Response to Submissions

for the
Recommencement
of Mining
Operations at the

Broken Hill North Mine

Application No. SSD 7538

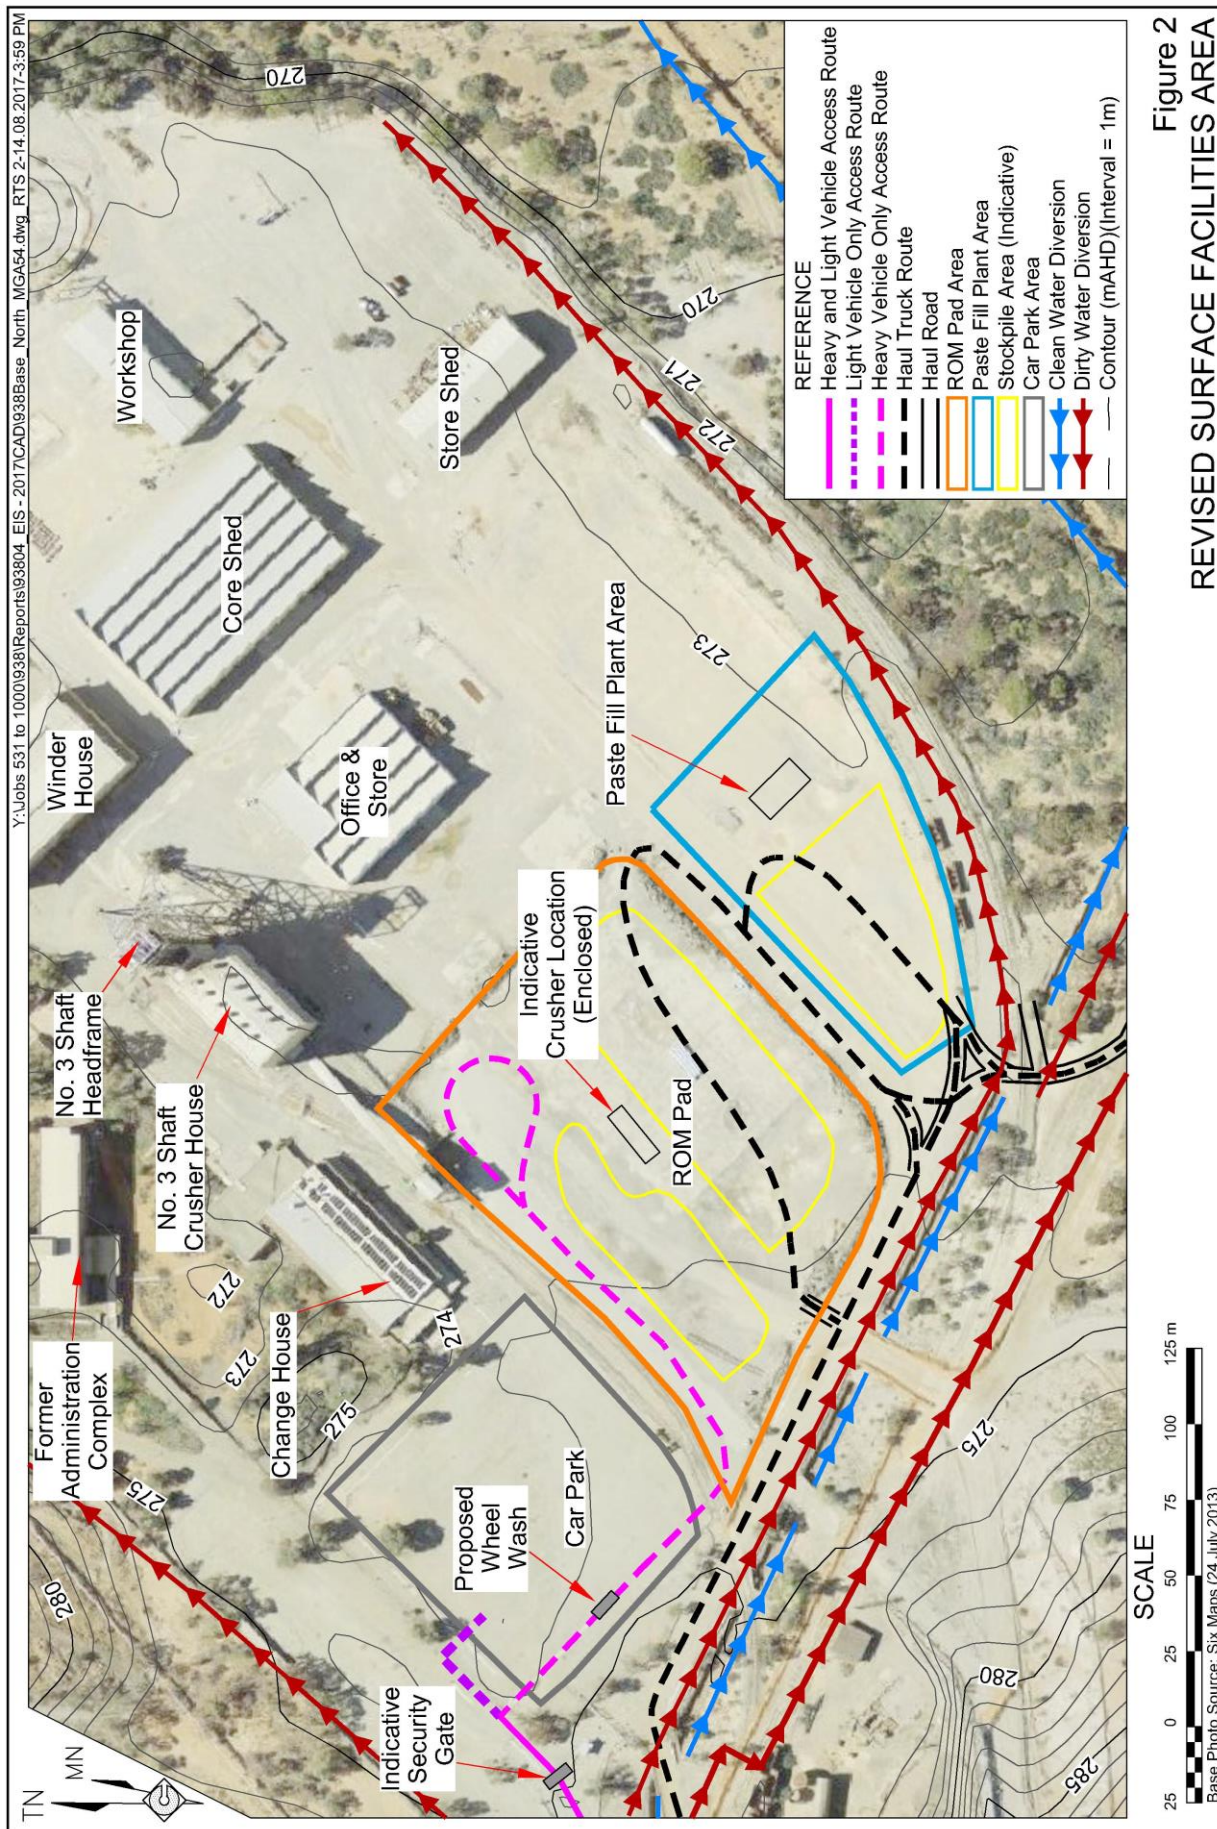
In light of the feedback received, the Applicant proposes to construct an enclosure for the mobile crusher (**Figure 2**). The enclosure would be located within the ROM Pad area and would include dust extraction and collection that would result in negative pressure within the crusher enclosure. Collected dust would be removed from the Mine Site for processing at the Southern Operations concentrator.

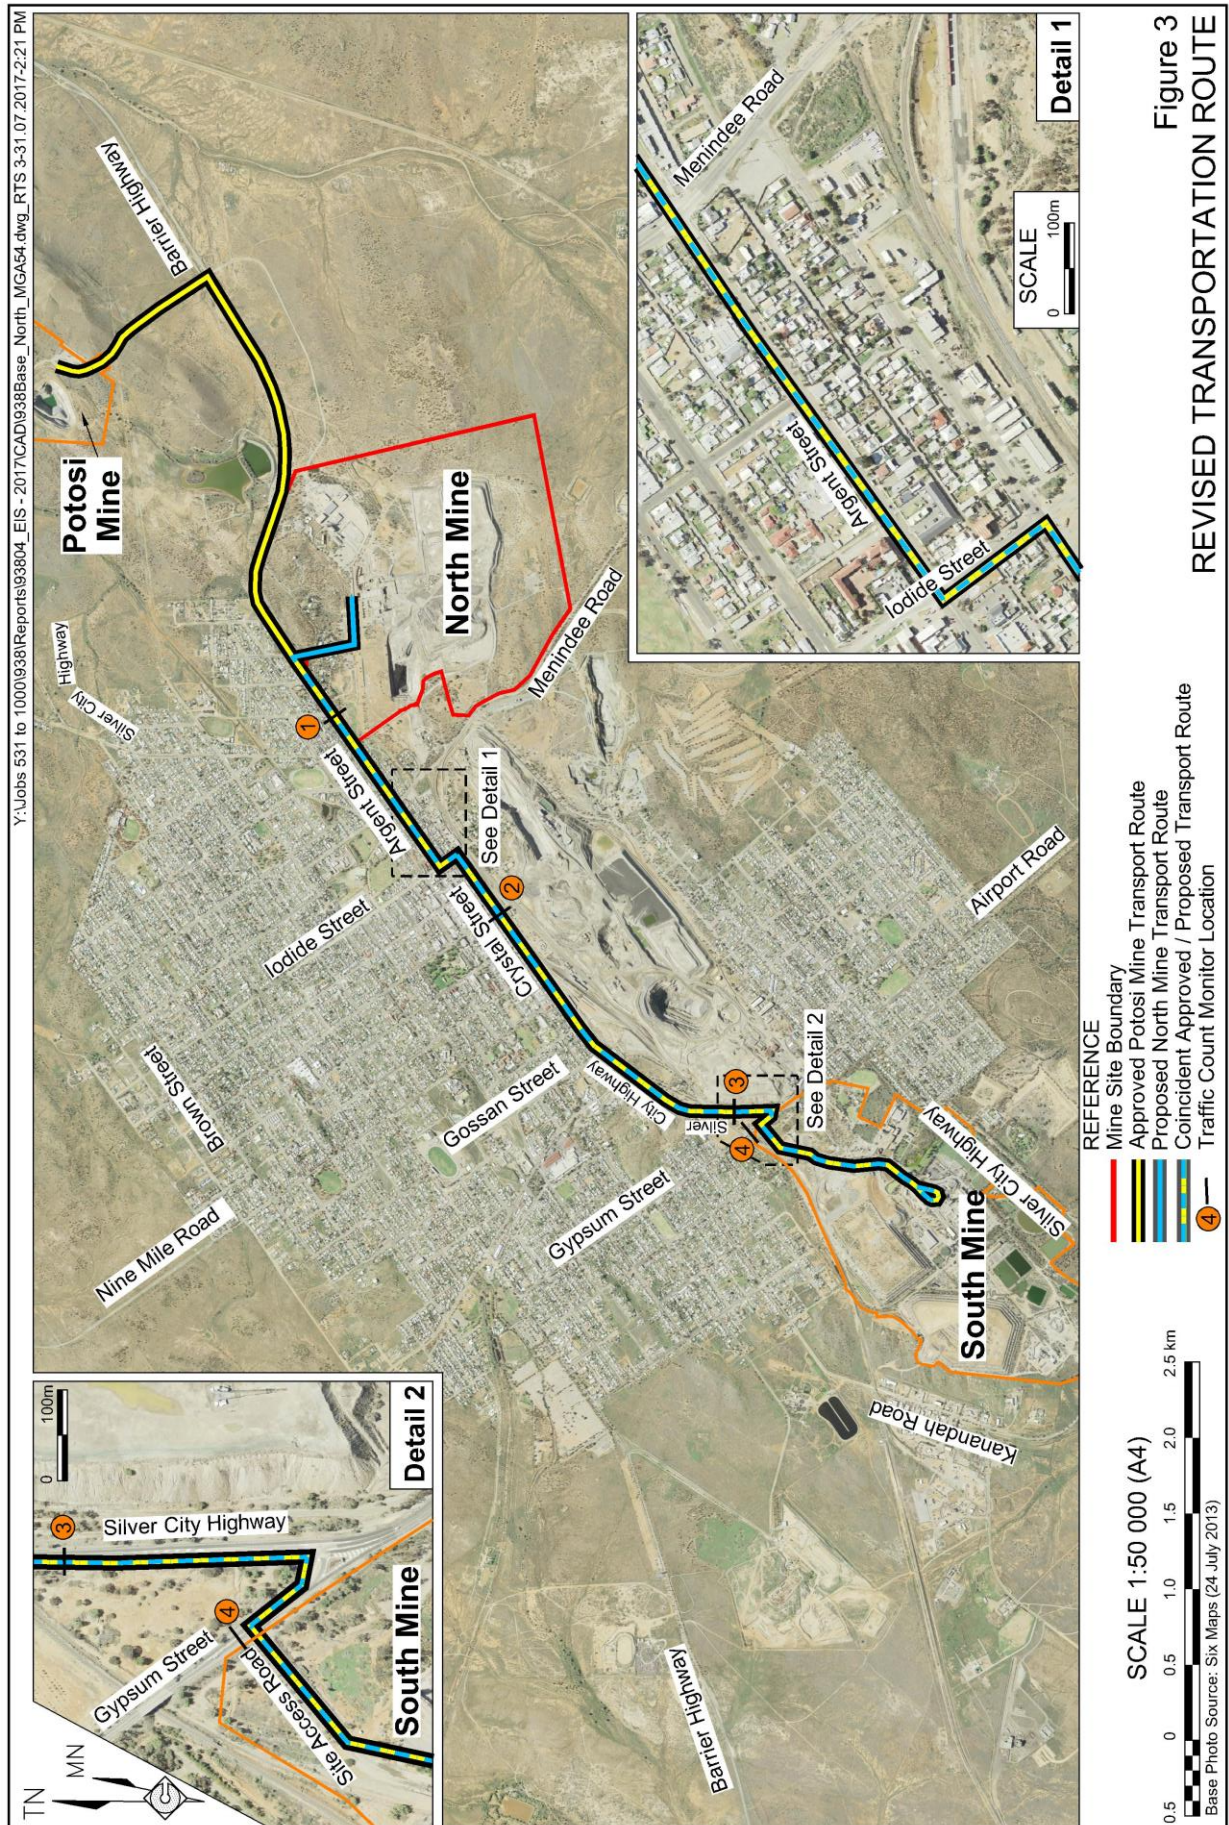
In light of the above, the Applicant has revised the proposed transportation route for this application to be consistent with that approved for the Potosi Mine, namely via the Barrier Highway and Iodide Street. **Figure 3** presents the revised transportation route for which approval is sought under this application.

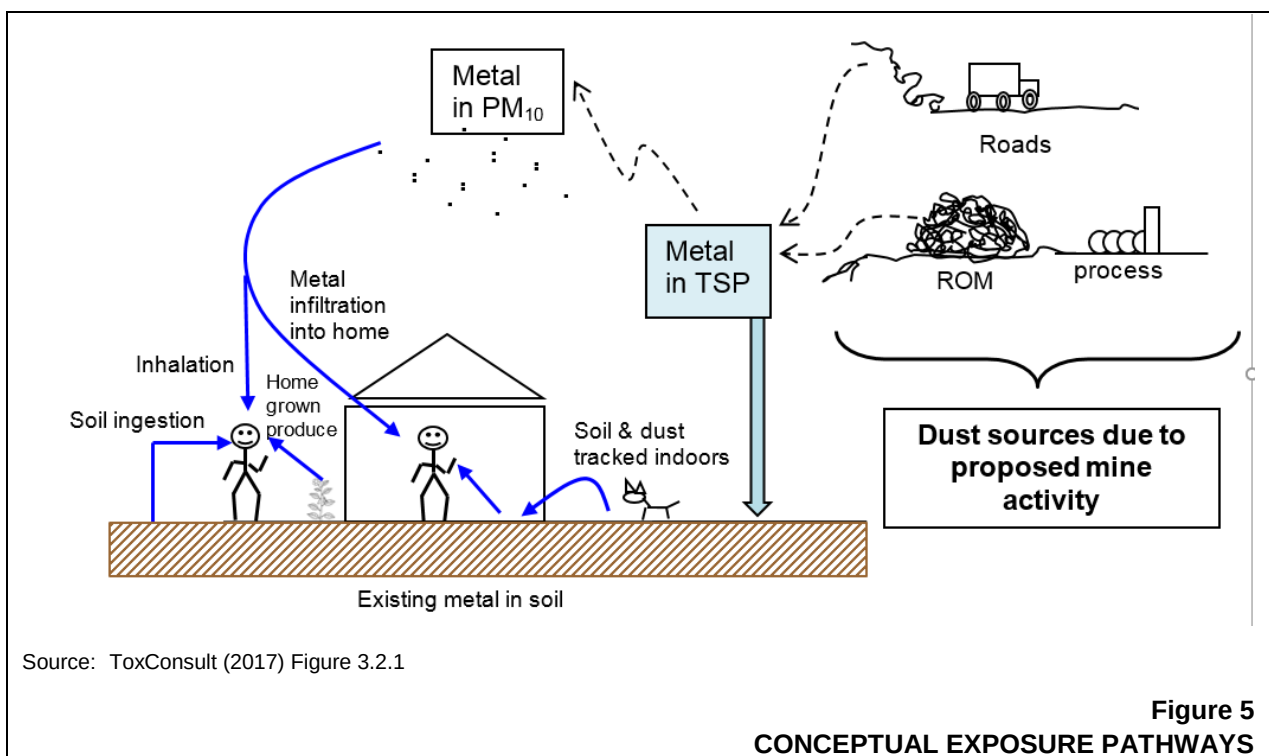
The HRA should be revised to include a detailed and site specific conceptual site model for the proposal.

Figure 5 presents the conceptual exposure pathways for lead and other metals. In summary, there are three principal pathways for lead to enter the human body. In order of significance, these are as follows.

Figure 6 presents an overview of planned stopes classified by distance to the closest privately-owned residence.

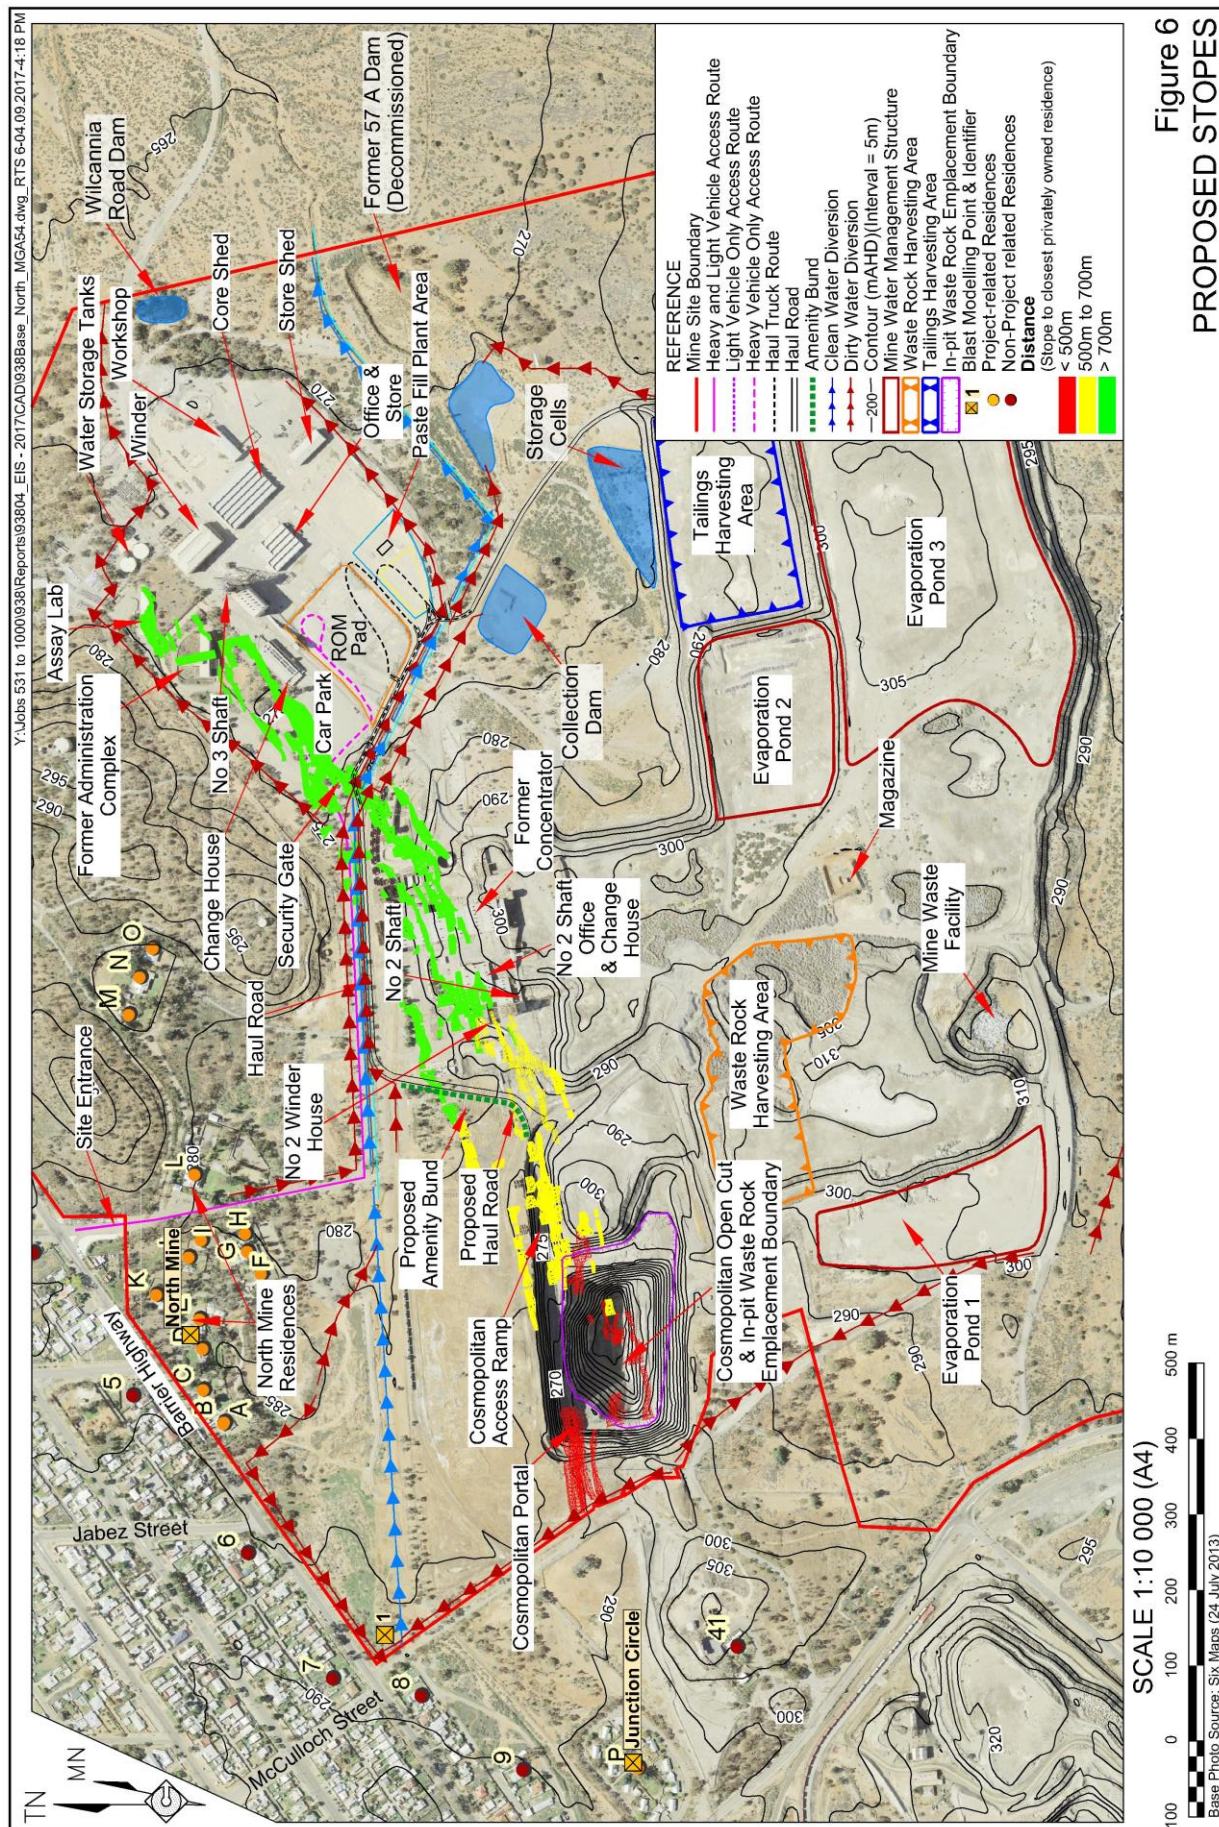
The inputs for the prediction of blast impacts at residential receptors are not clear and the blasting calculation is oversimplified considering the number of variable blasting configurations controlled by the proponent. The distance to receptors in the blast calculation also appears to be incorrect based on Figure 2.6 in the EIS and discussions with the proponent which indicates blasting and mining may commence from the base of the Cosmopolitan open cut.

- The minimum point-to-point distance¹¹ between proposed stope blasting operations (on Level 4 in the vicinity of the Cosmopolitan Open Cut) and a privately-owned residence (Residence 8 on **Figure 6**) is 344m. Distances between stopes to the mined and privately-owned residences increase with:

- Establish an additional fixed blast monitoring location on Perilya-controlled land adjacent to the residence at 617 Argent Street (Residence 8 on **Figure 6**).
